Review Comments on the "*Minimum Levels Reevaluation For Sylvan Lake, Seminole County, Florida*"
Draft Report Released on January 22, 2021

Liquid Solutions Group, LLC
April 1, 2021

On behalf of Orange County Utilities (OCU), Liquid Solutions Group, LLC (LSG) has performed a preliminary review of the "Minimum Levels Re-Evaluation For Sylvan Lake, Seminole County, Florida" draft technical publication prepared by the St. Johns River Water Management District (SJRWMD), dated 2021 (i.e., file name: Sylvan_LakeDraftMFLsReport_2021_0122.pdf). Based on this review, LSG has developed comments on the Minimum Flow and Levels (MFL) evaluation for consideration by the SJRWMD and the Peer Review Panel.

**Figure 1**. Sylvan Lake NP UFA Head Series and Rainfall.

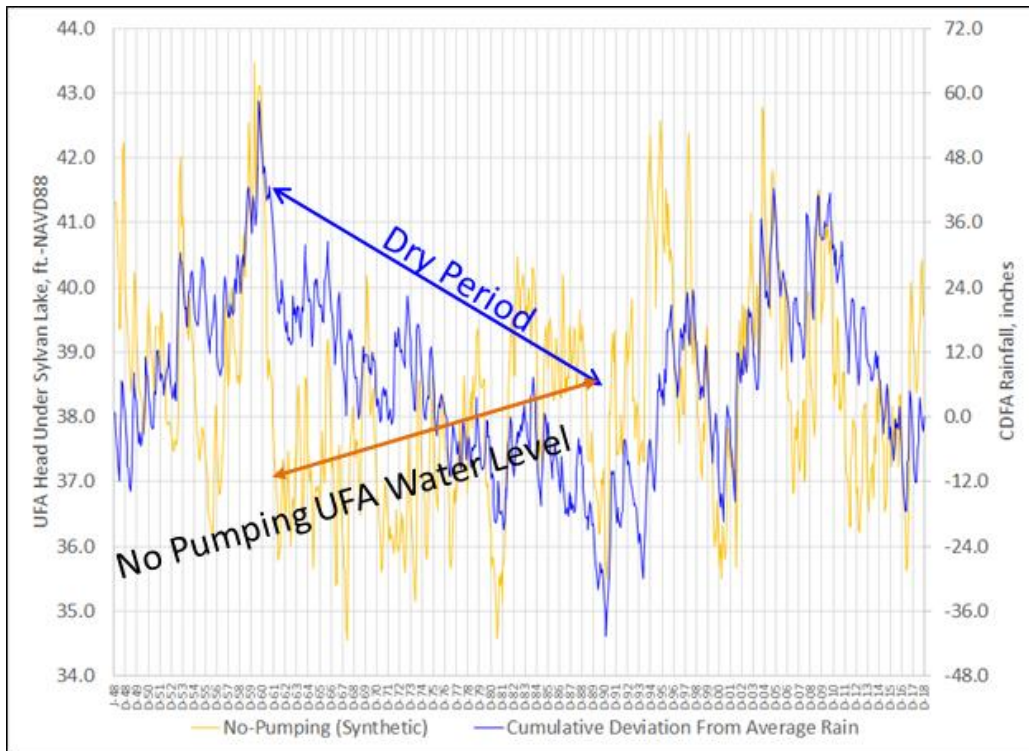
1. **Figure 1** shows a comparison of the long-term rainfall series used in support of the Sylvan Lake MFL re-evaluation study (expressed as cumulative deviation from average rainfall) and the simulated long-term NP UFA head series derived for Well S-0718. As shown in **Figure 1**, the rainfall pattern and trends deviate from the variability exhibited by the synthetic NP UFA head series for the period from the early 1960's through the late 1980's. Since the NP UFA head series does not include the effect of groundwater withdrawals, the NP UFA head series would be expected to reflect historical rainfall conditions.

To address these concerns, we would recommend that the SJRWMD evaluate methods for adjusting the NP UFA head series for S-0718 to better reflect the historical rainfall conditions. One method could include an adjustment to correct for the temporal anthropogenic differences between these two locations.

Figure 2. Extension of UFA head series near Sylvan Lake (Well S-0718).

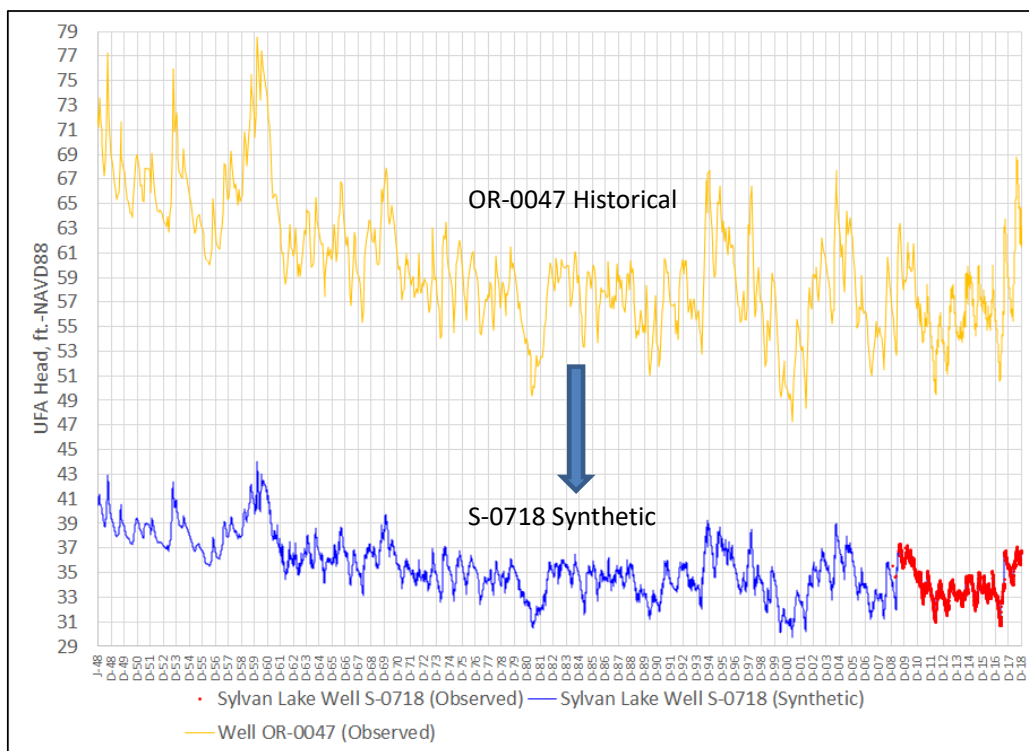
A potential reason for the deviation between NP UFA levels and rainfall trends is the use of Well OR-0047 as a surrogate site for the development of a UFA head series representing historical conditions near Sylvan Lake (Well S-0718). As shown in **Figure 2**, the use of Well OR-0047 imparts characteristics (anthropogenic and hydrological variability) on Sylvan Lake UFA heads. However, Well OR-0047 and Well S-0718 are located almost 20 miles apart from each other (**Figure 3**). While the Sylvan Lake MFL re-evaluation analysis shows that a good correlation has existed between the observed heads at these two sites in recent years, extending the UFA head series at Sylvan Lake back in time assumes this correlation also existed historically outside the period of record for S-0718.

Figure 4. Historical Pumpage near Well OR-0047 and Well S-0718.

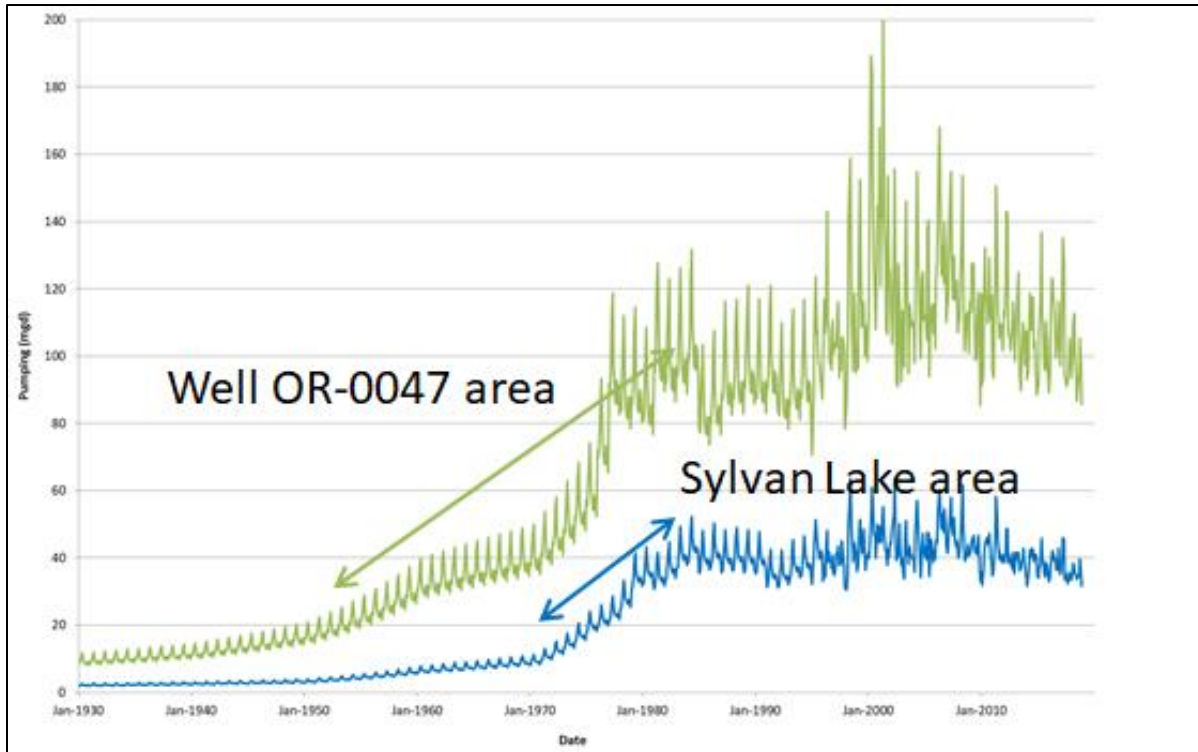
A potential major difference between the anthropogenic characteristics of the two UFA wells sites is the historical pumpage. UFA heads variability and trends observed at Well OR-0047 are expected to be more characteristic of pumpage in western Orange County. While heads variability and trends observed at Well S-0718 are expected to be more characteristic of pumpage in Seminole County, closer to Sylvan Lake. **Figure 4** shows that historical pumpage in the vicinity of these two sites exhibit different temporal patterns and trends, with pumpage starting to increase in the late 1950's in Orange County (Wekiva Basin pumping used), and in the 1970's in Seminole County (around Sylvan Lake).

Figure 5. Linear Regression Used to Estimate UFA Historical Impacts for Conversion from Historical Conditions to NP Conditions.

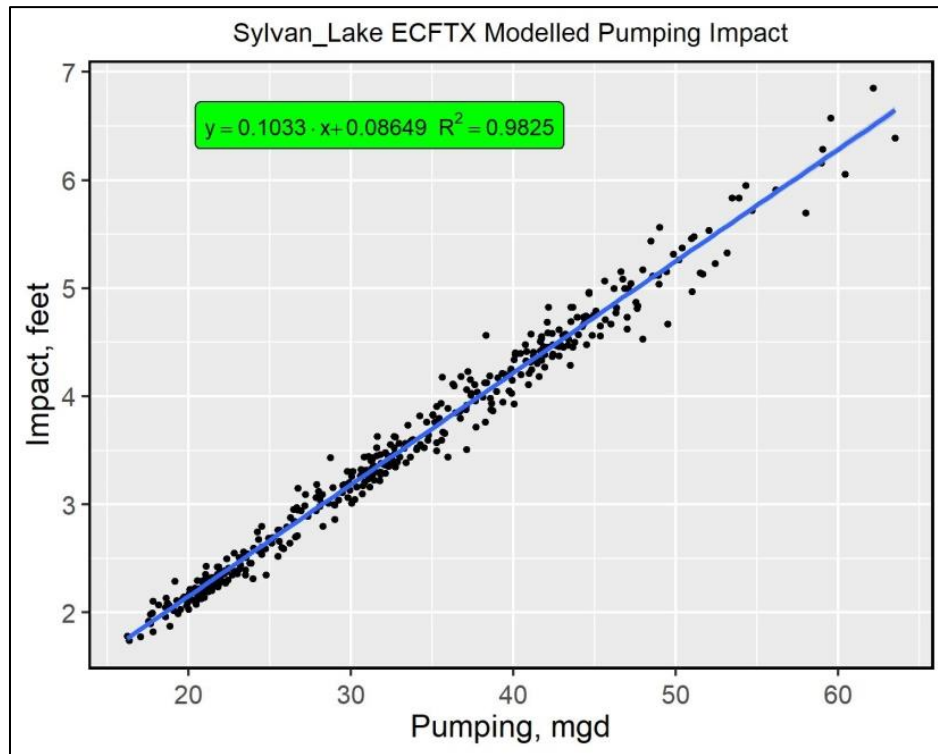
In another step of the process, the District is developing a linear regression (**Figure 5** and Figure B-14 of Appendix B of the Sylvan Lake MFL re-evaluation draft technical publication) relationship between impact and pumping around Sylvan Lake based on the ECFTX calibration simulation and related derived simulations. This regression relationship was used to estimate historical drawdowns (groundwater impacts) to convert the synthetic long-term historical UFA head series into the long-term NP UFA head series.

Applying these two different methodologies, one based on actual drawdown from an ECFTX 2014-2018 model simulation and another based on linear regression of ECFTX calibration and related simulations, introduces a potential inconsistency into the process of calculating CP UFA heads.

The CP UFA impact produced by the ECFTX 2014-2018 Model is 4.247 ft. However, the average CP UFA impact derived using **Figure 5** for monthly pumping from 2014-2018 is 3.955 ft. This difference shows that the linear regression underpredicts current impacts by 0.292 ft., relative to the results derived directly from the ECFTX Model.

As a result, the conversion of the synthetic long-term historical UFA head series into the NP condition is being underestimated by about 0.292 ft. If the long-term NP UFA head series is underestimated by about 0.292 ft., then long-term CP UFA head series is also underestimated by the same amount, because the UFA CP condition is just a constant offset value (4.247 ft.) subtracted from the UFA NP condition. If the UFA CP condition is underestimated, then the simulated long-term CP lake stage series is also underestimated as shown in **Table 1**.

It appears that there are multiple methods to increase consistency between the steps in the process of calculating CP UFA heads. We recommend that the SJRWMD evaluate and implement changes to address this concern.

Figure 6. Sylvan Lake 2014 Structure Improvement.

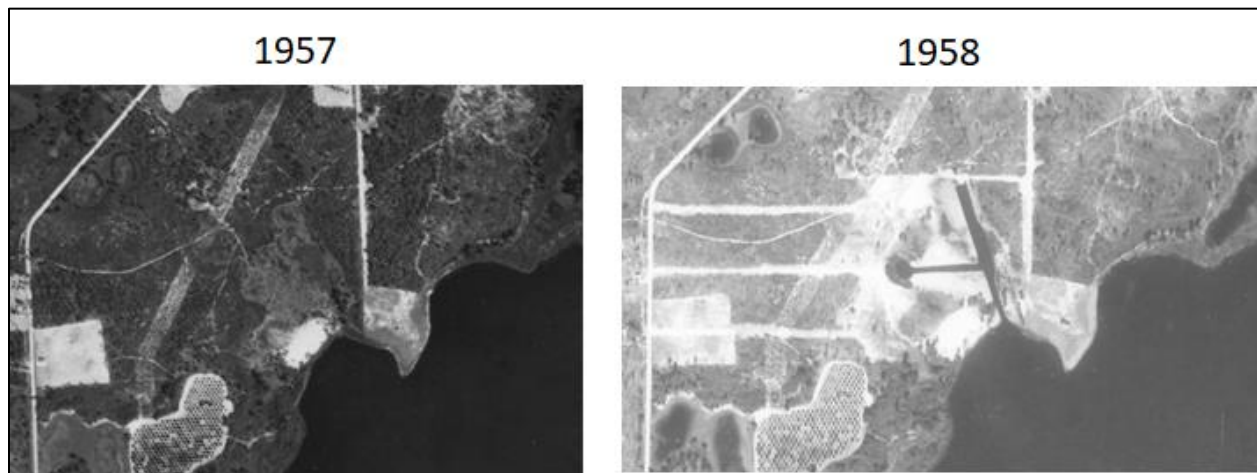
3. Sylvan Lake's long-term CP lake stage series is simulated using Sylvan Lake's post-construction outflow values resulting from a structure improvement located at the north end of Sylvan Lake in 2014. **Figure 6** shows the outflow structure improvements. However, additional structural changes (i.e., canal construction), further enhancing discharges from the lake, have also occurred historically (**Figure 7**). The Sylvan Lake MFL re-evaluation does not appear to address or quantify the potential effects resulting from the construction of these historical improvements.
